May 26, 2017

TO : All Bidders
FROM : George M. Wiens
PROJECT : CTE Classroom Addition
1615400.41
SUBJECT : Addendum 1
DSA : 04-115755 / 33-H18

DRAWING NUMBER: **E4.1**

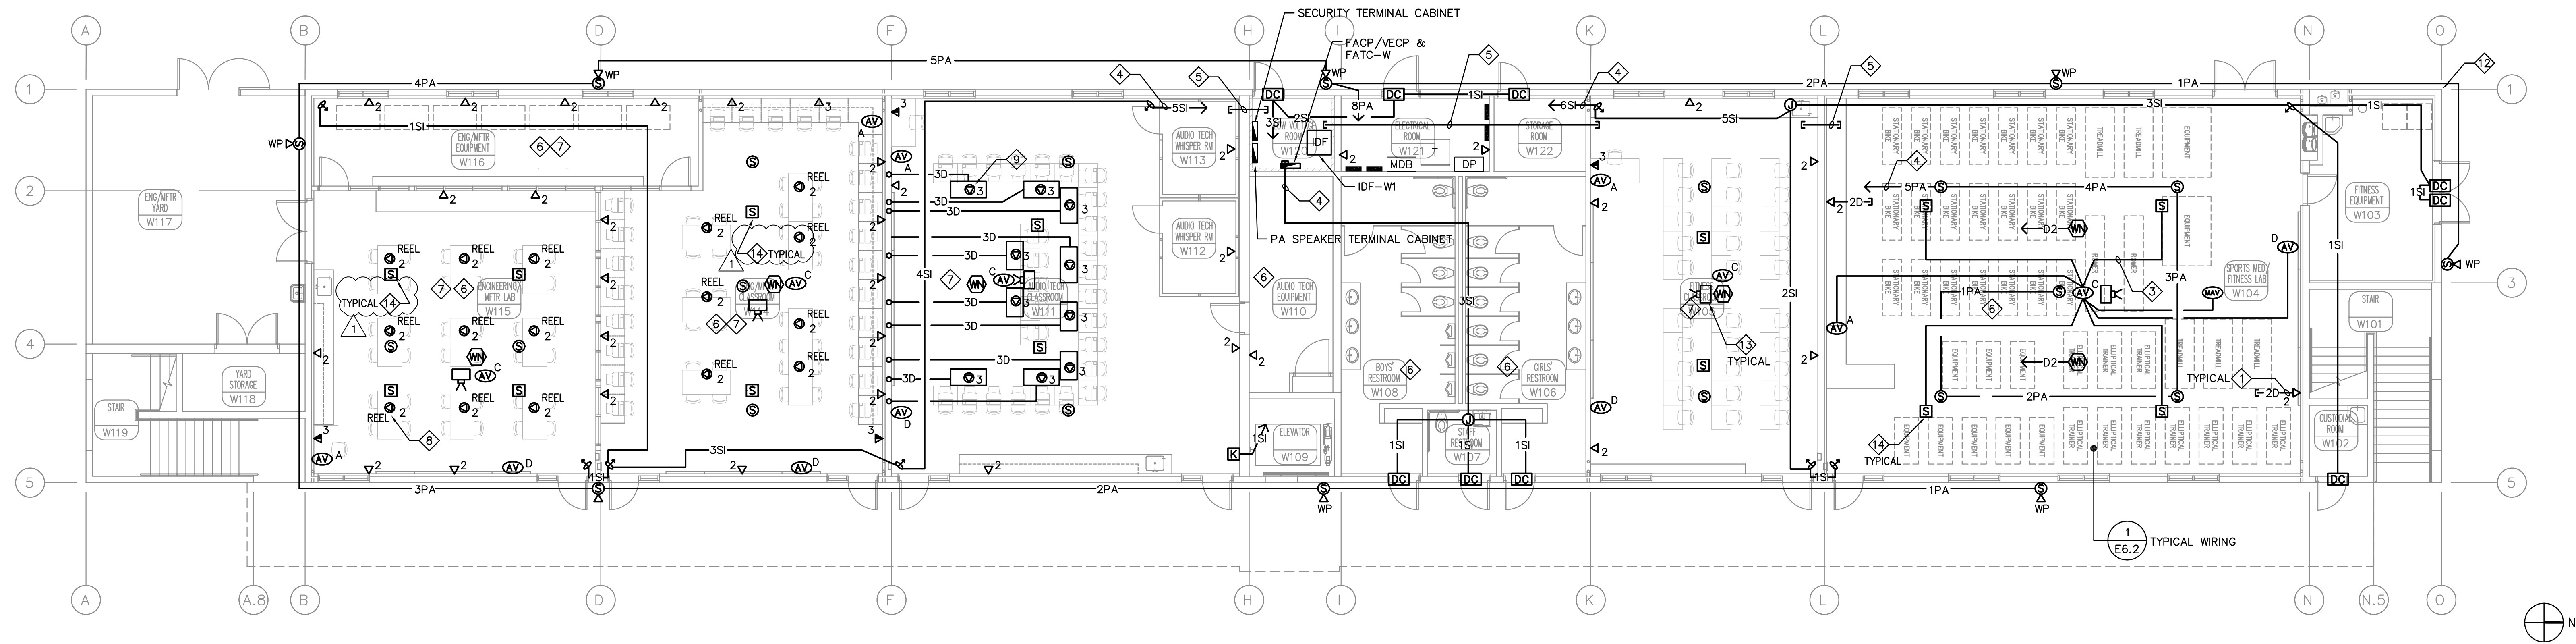
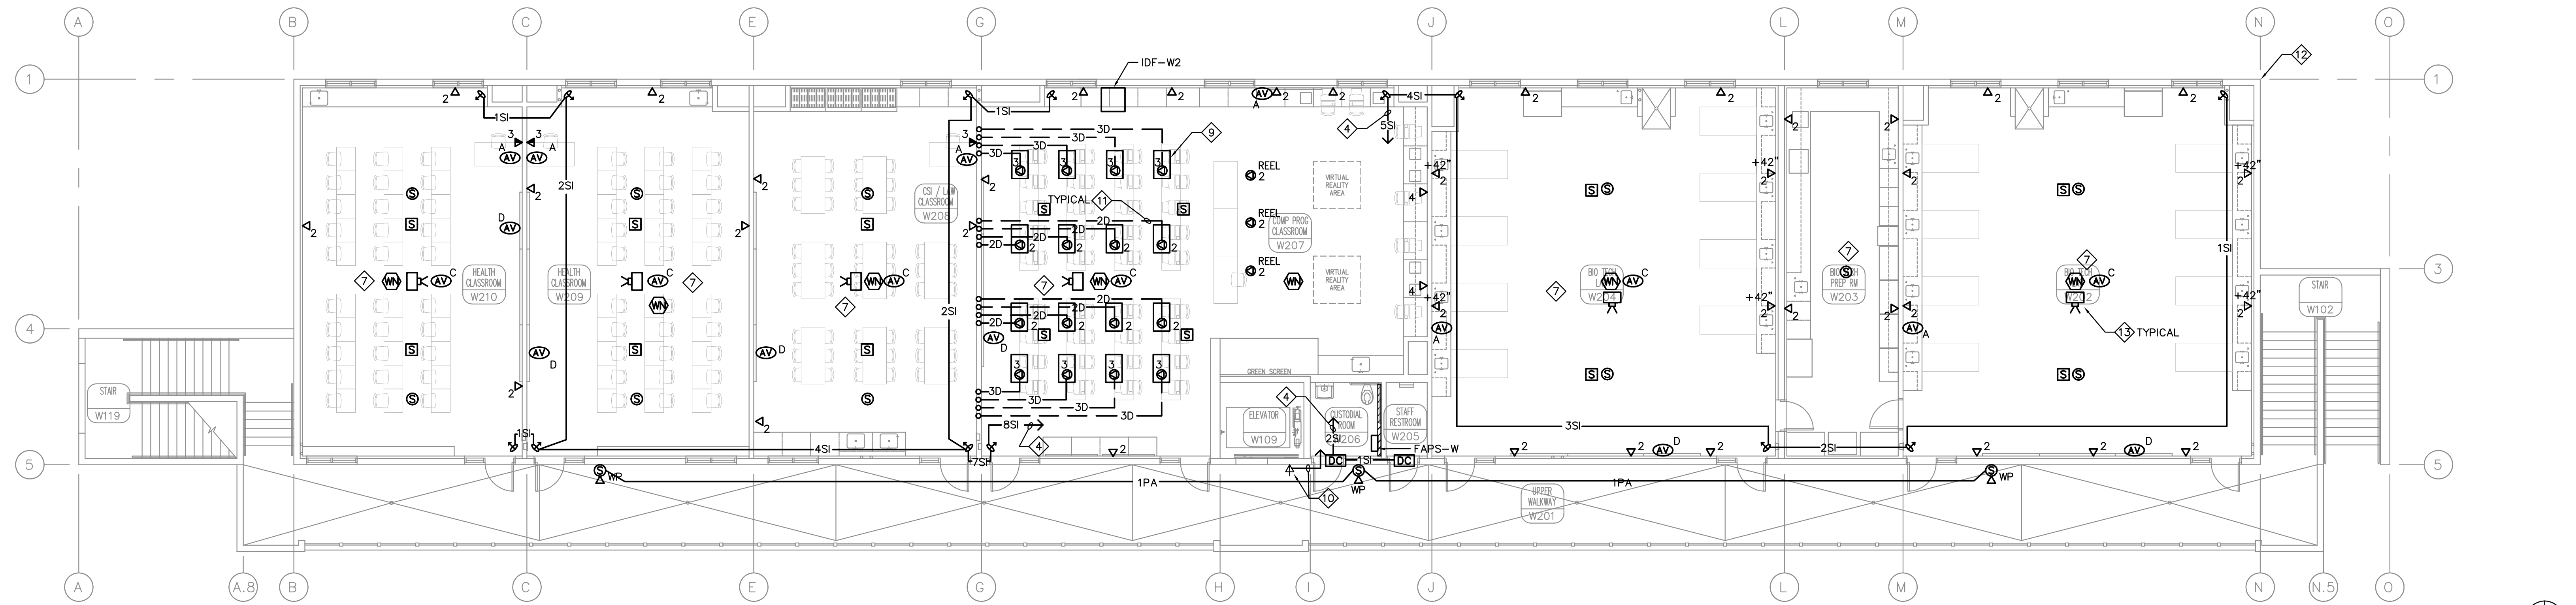
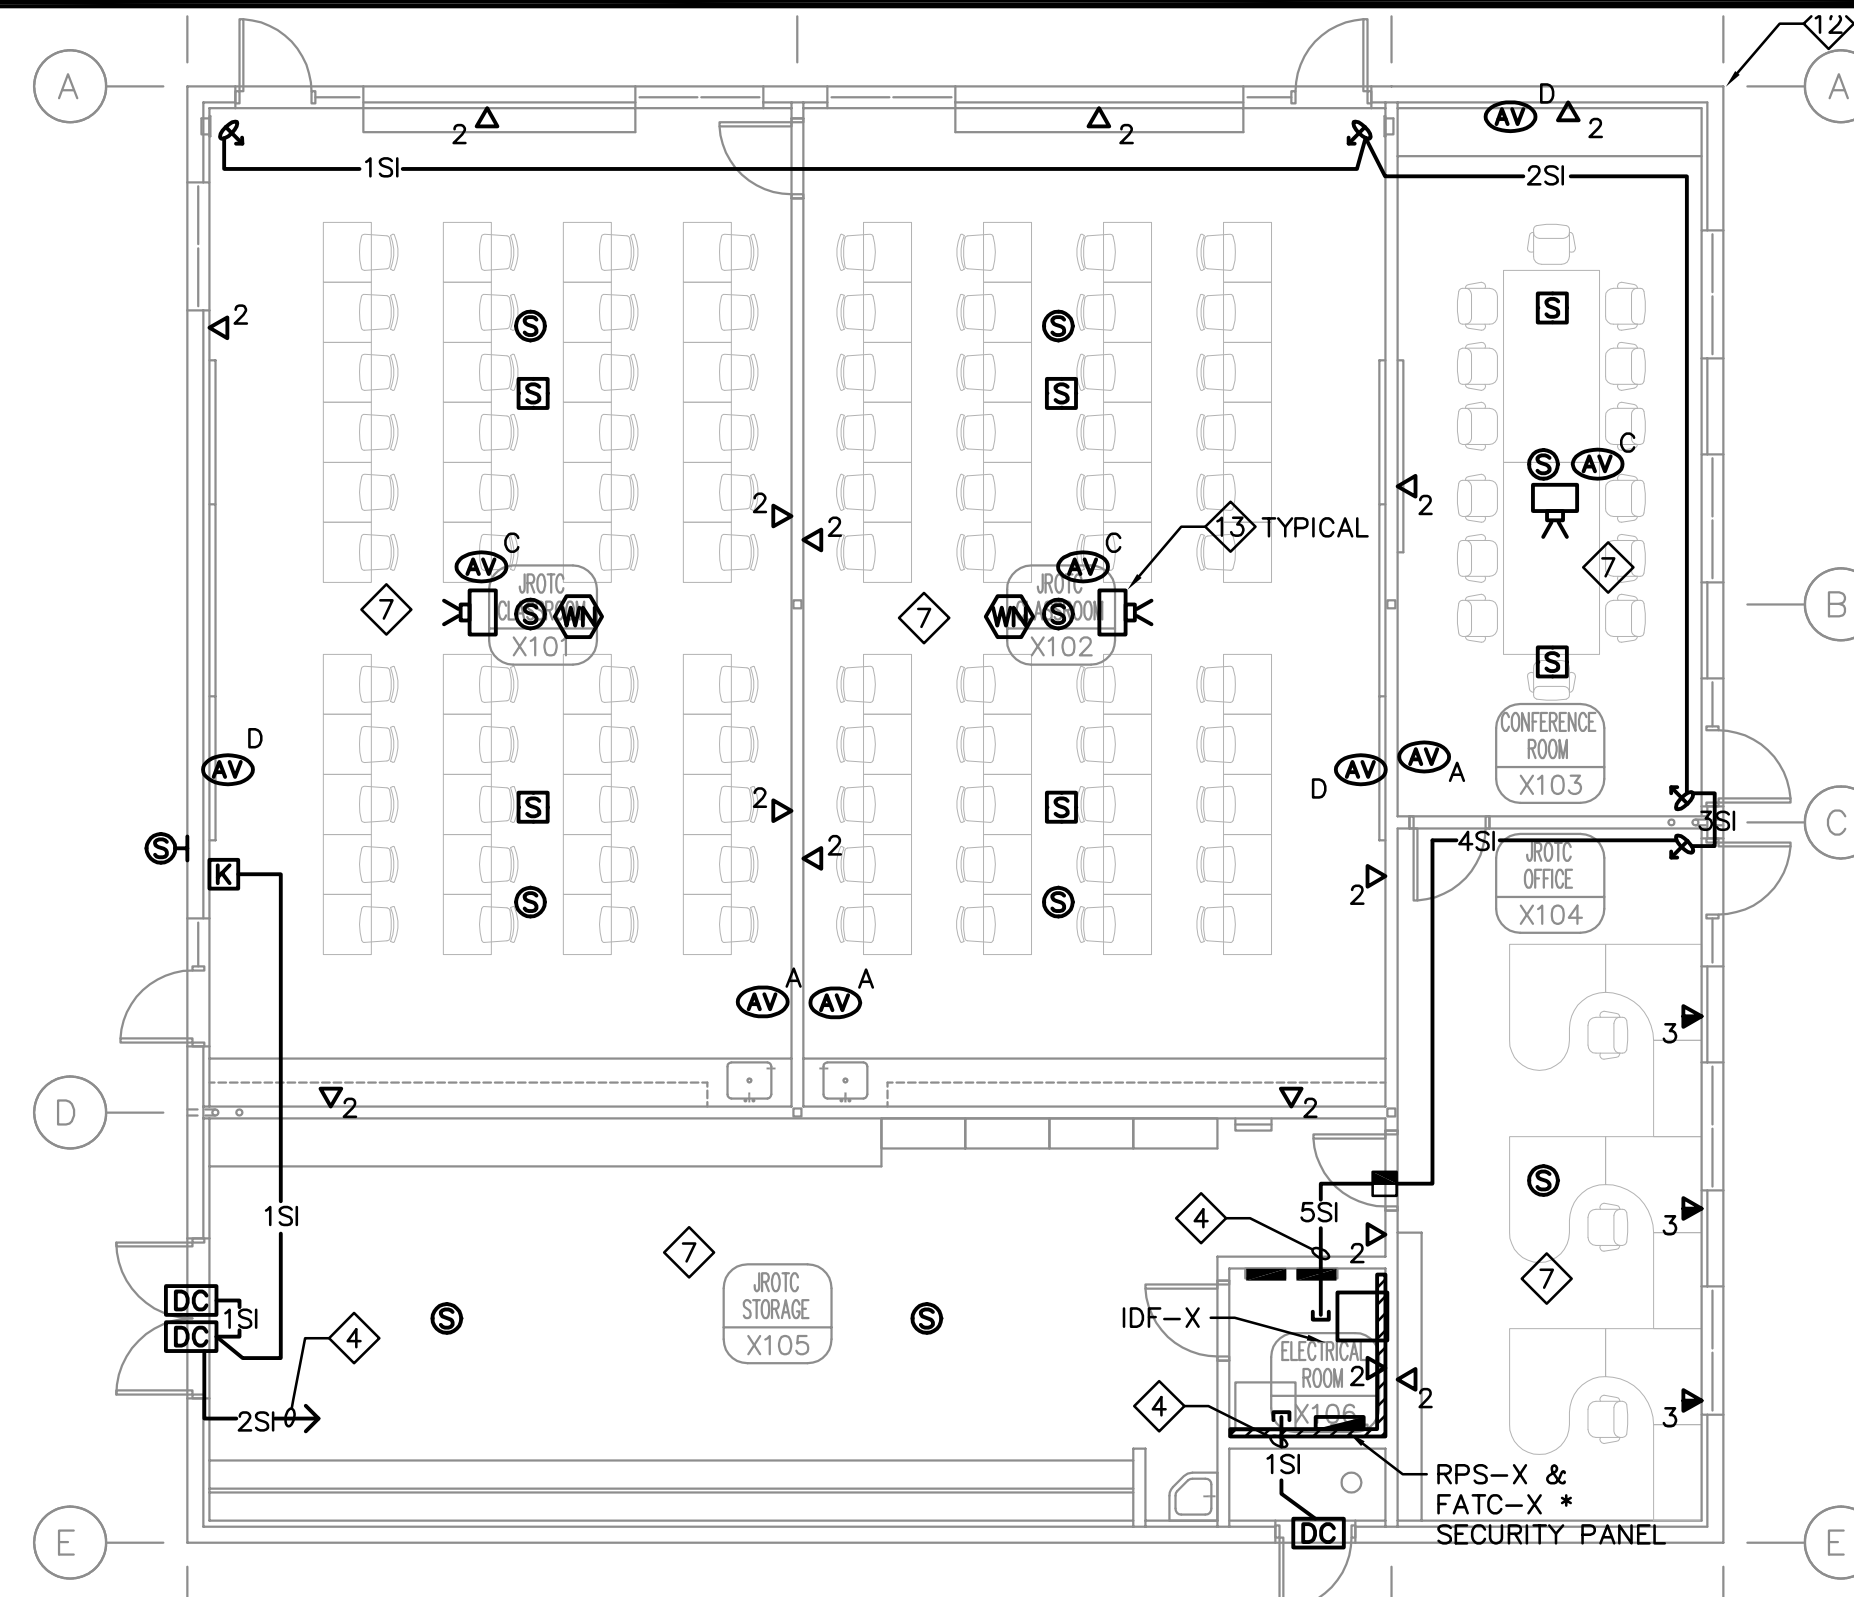
A. Revise as indicated in the clouded area labeled Delta 1 on the attached E4.1.
